SUBJECT: SPECIAL USE AND PRELIMINARY SITE PLAN REVIEW (File Number SU 117-D)
– Proposed St. Mark Coptic Orthodox Church improvements, West side of Livernois, South of Wattles (3603-3615 Livernois), Section 21, Currently Zoned R-1B (One Family Residential) District

Special Use and Preliminary Site Plan Review For City of Troy, Michigan

Applicant:	St. Mark Coptic Orthodox Church
Project Name:	Modular Classrooms and Parking Lot
Plan Date:	May 22, 2014
Location:	West side of Livernois, south of Wattles
Zoning:	R1-B, One Family Residential
Action Requested:	Preliminary Site Plan Approval
Required Information:	Noted Below

1 Landscape Plan

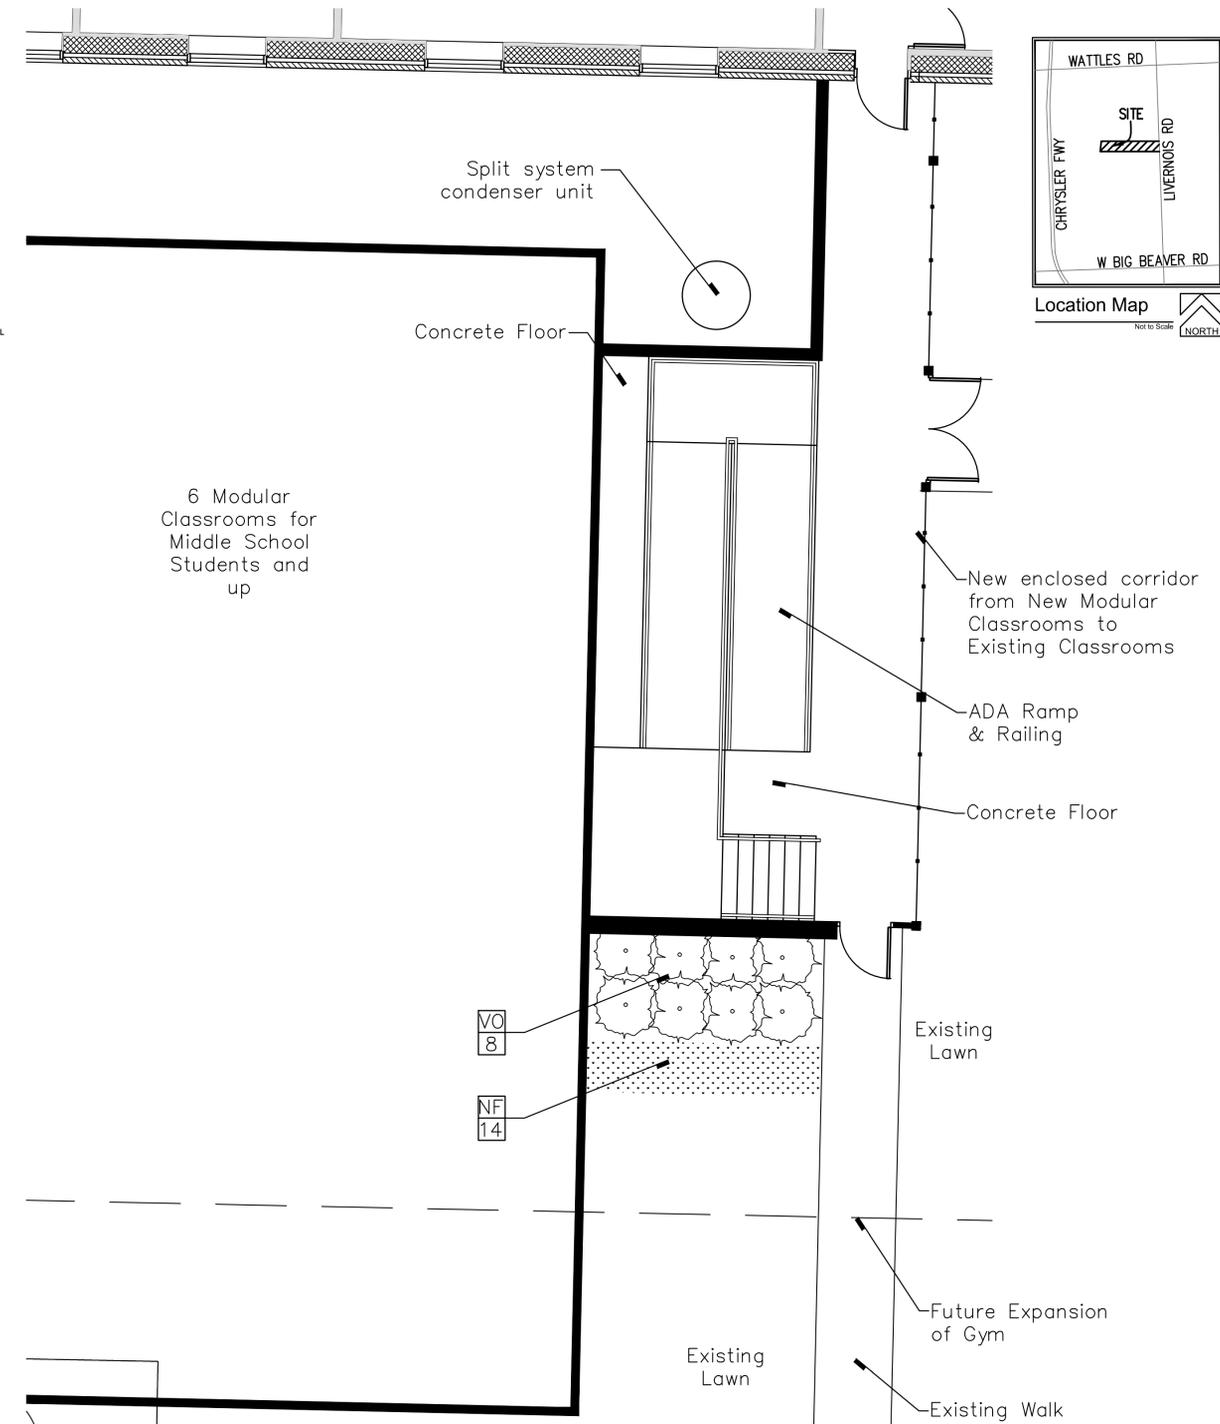
3. Provide required landscape for the new parking lot.

Items to be Addressed: Confirm to the satisfaction of the Planning Commission that landscape screening along southern property line is sufficient.

<u>Required:</u>	<u>Provided:</u>	<u>Compliance:</u>
<u>Parking Lot Landscaping:</u> 1 tree for every 8 parking spaces. Trees may be located adjacent to parking lot with planning commission approval.	36 spaces = 5 trees	Applicant has provided 5 trees however trees are not located within parking lot.	Interior parking lot landscaping on the periphery of the parking lot may be approved by the Planning Commission
<u>Exterior Parking Lot:</u> Either 1 tree per 3 lineal feet of narrow evergreen or 1 tree per 10 lineal feet of large evergreen.	170 feet = 57 narrow evergreen or 17 large evergreen on north side of parking lot	5 new evergreen + existing evergreen screen along north property line	Compliant

The applicant notes there currently exists a berm and landscaping to screen the modular classroom.

CLASSROOM FLOOR PLAN
 SCALE: 1/8" = 1'-0" TYP. LAYOUT PER MODULAR SOLUTIONS

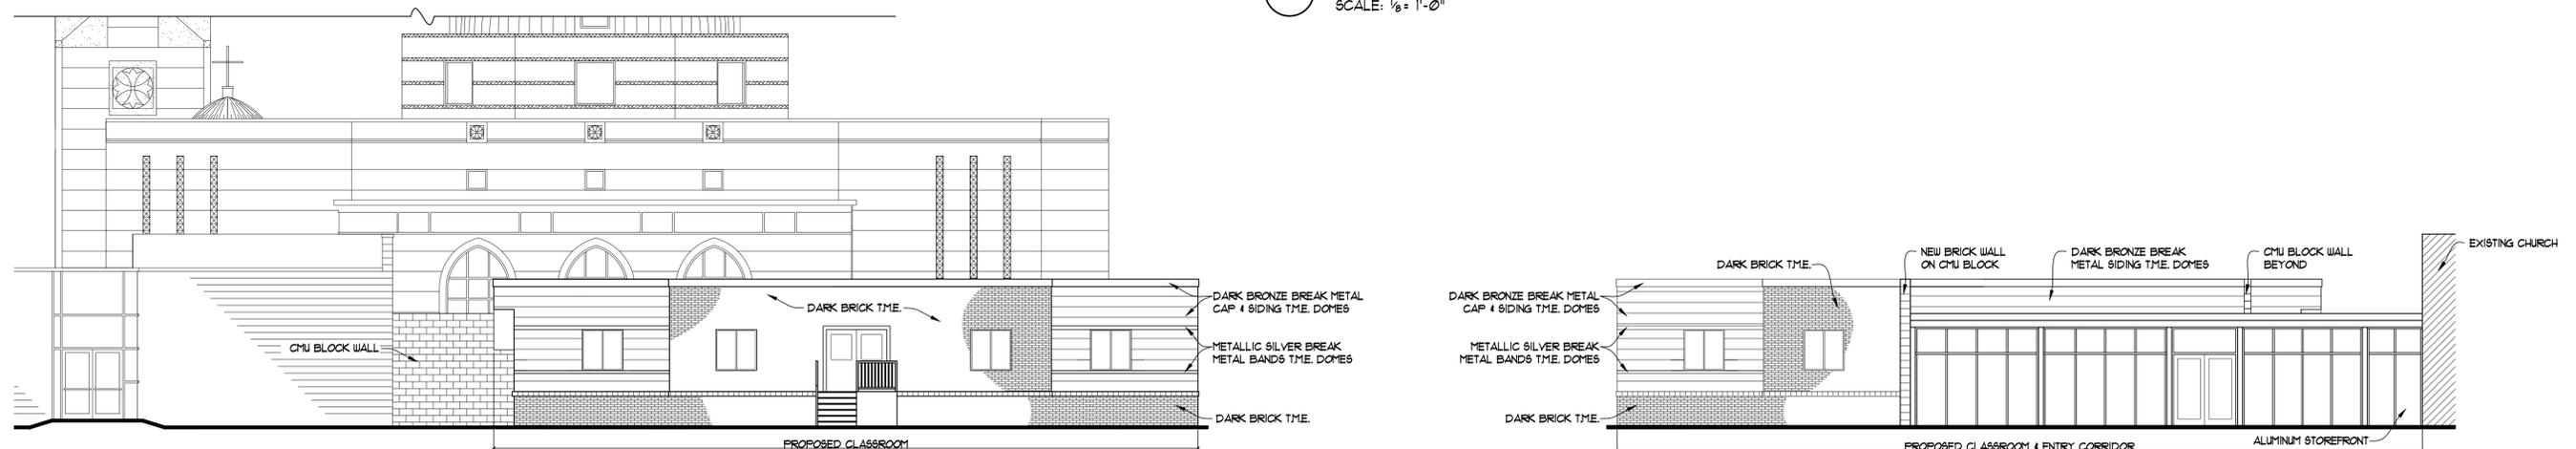
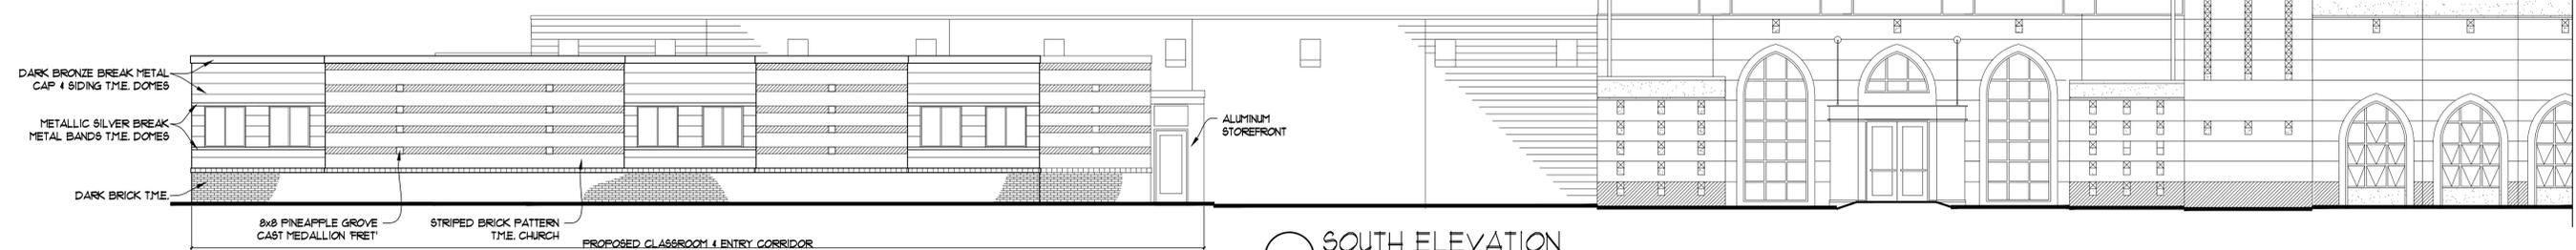
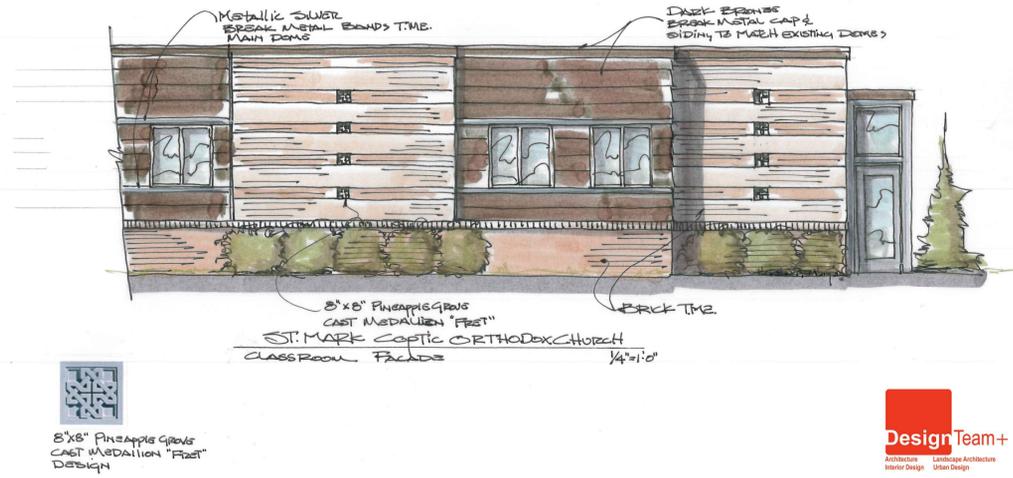
5. Address building code need for internal restroom.

6. Consider façade enhancements to classrooms.

The applicant will provide a masonry and storefront corridor from the classrooms to the church, thus eliminating the requirement to have an internal bathroom.

The applicant has proposed significant improvements to the classroom façade and exterior corridor. These improvements include dark brick and CMU block to match existing church, metal siding and capping, and an aluminum storefront. The Planning Commission shall determine if the proposed façade enhancements make the building compatible with adjacent uses and the existing church building.

Plan View
Scale - 1" = 30'

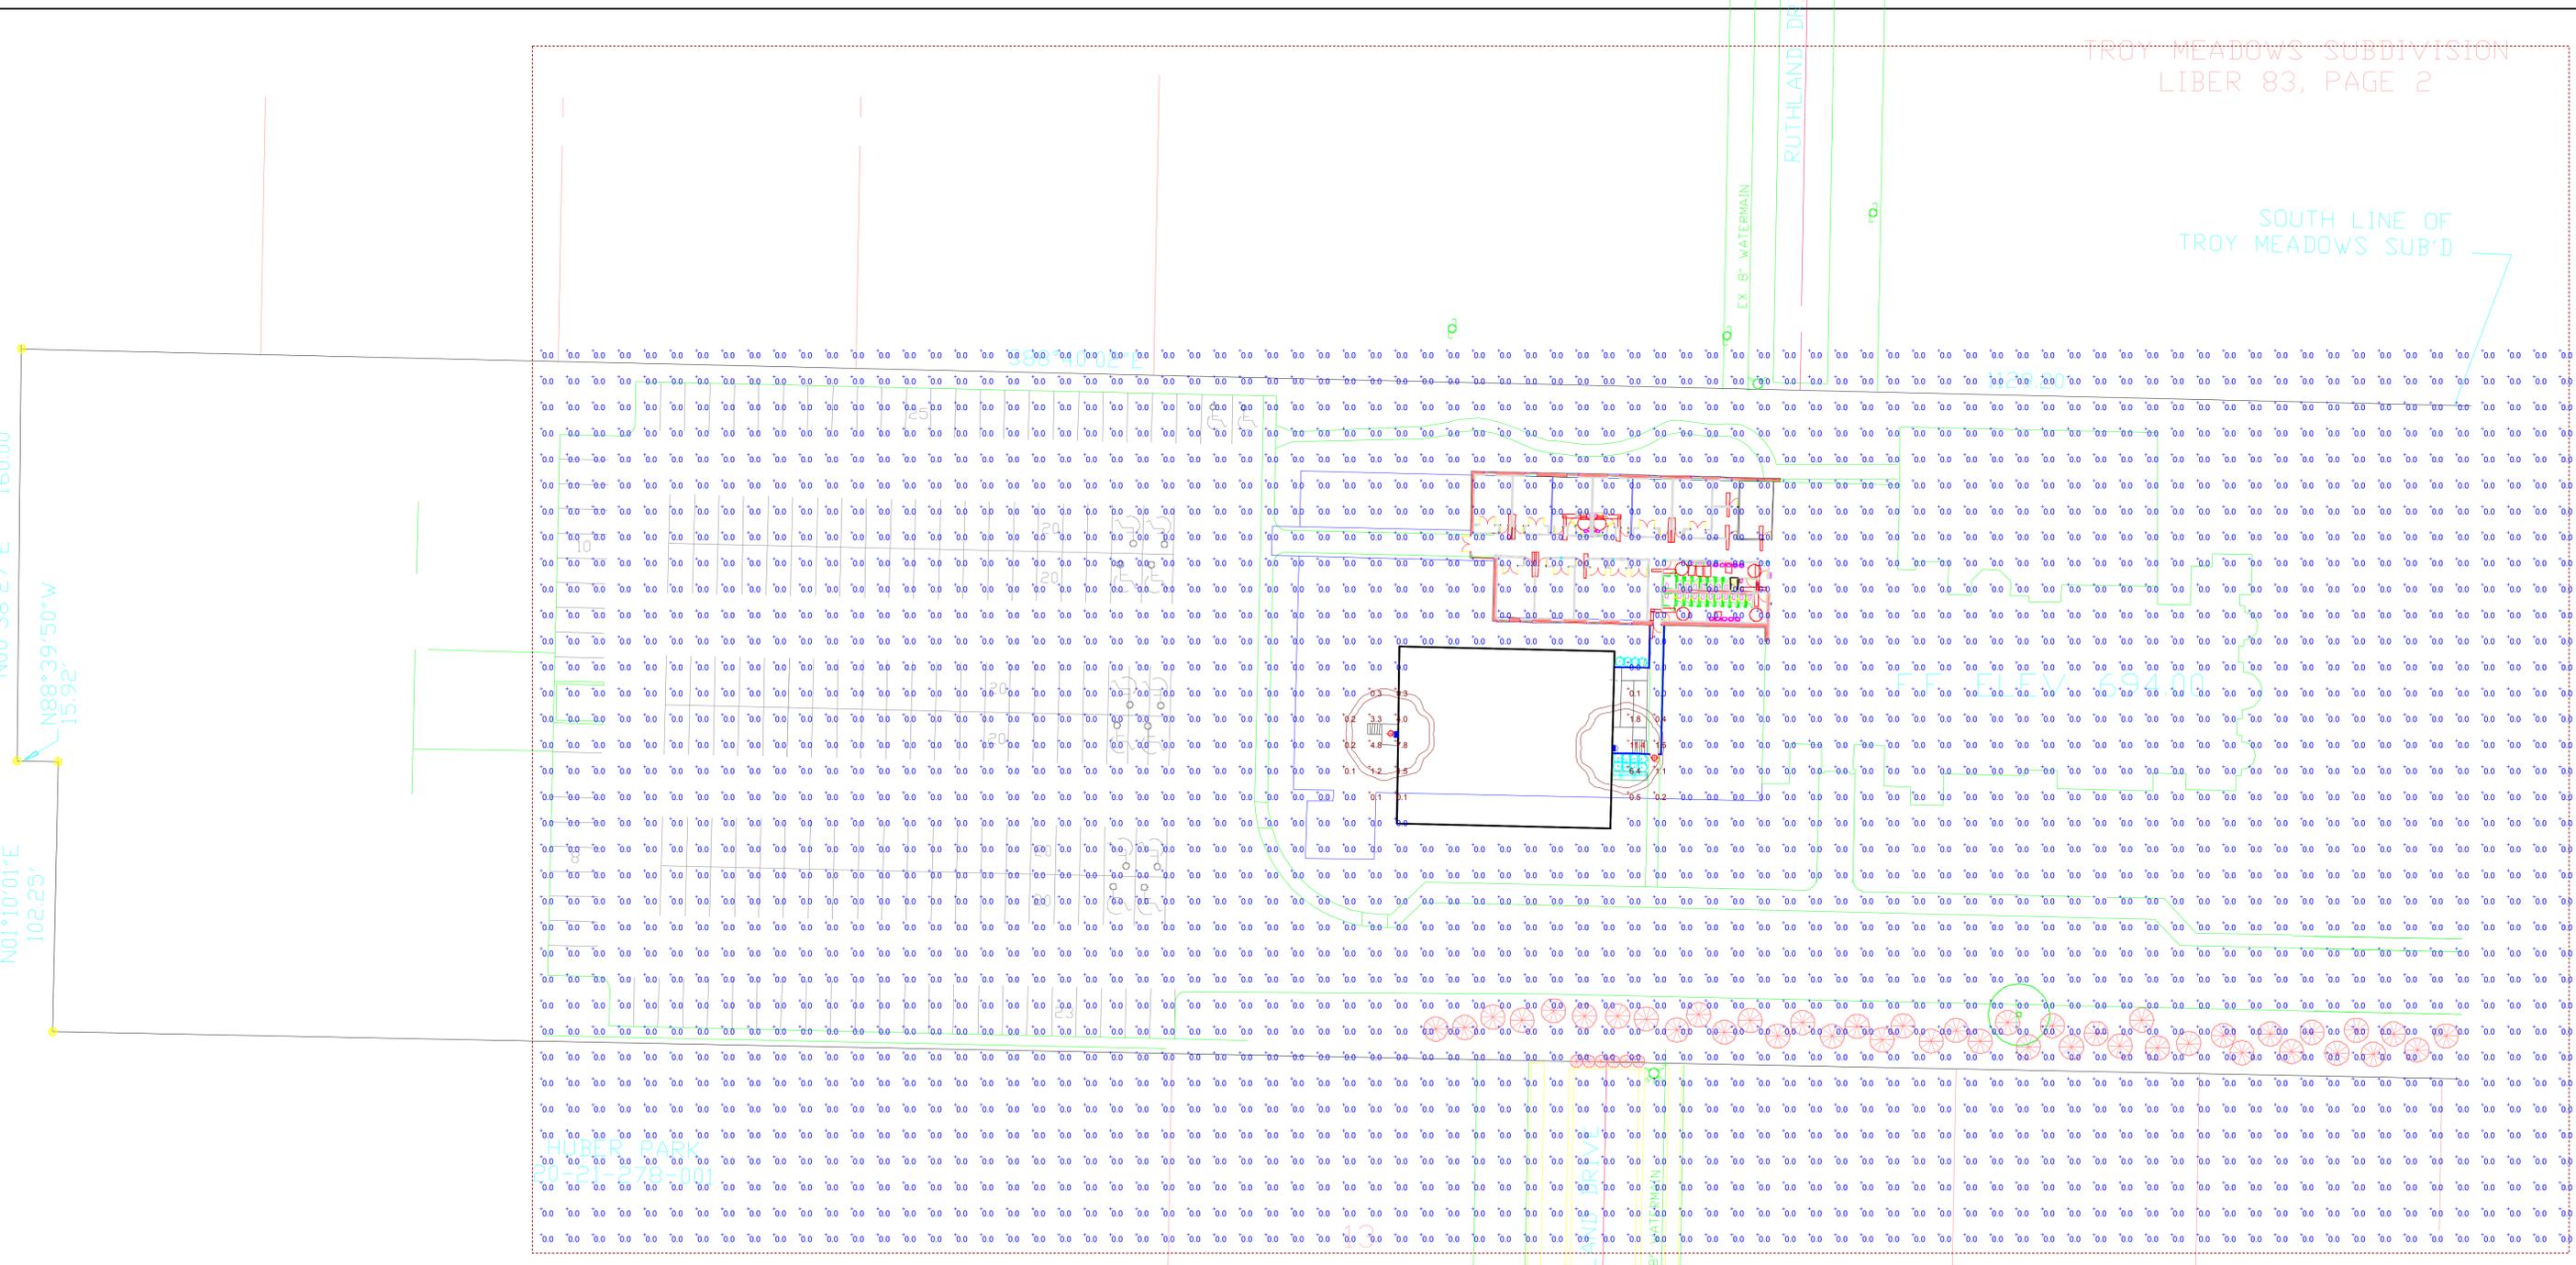
7. Provide classroom building light fixtures and confirm glare protection.

The applicant is adding two (2) wall sconces to the modular classroom addition. The sconces are fully shielded and comply with ordinance requirements.
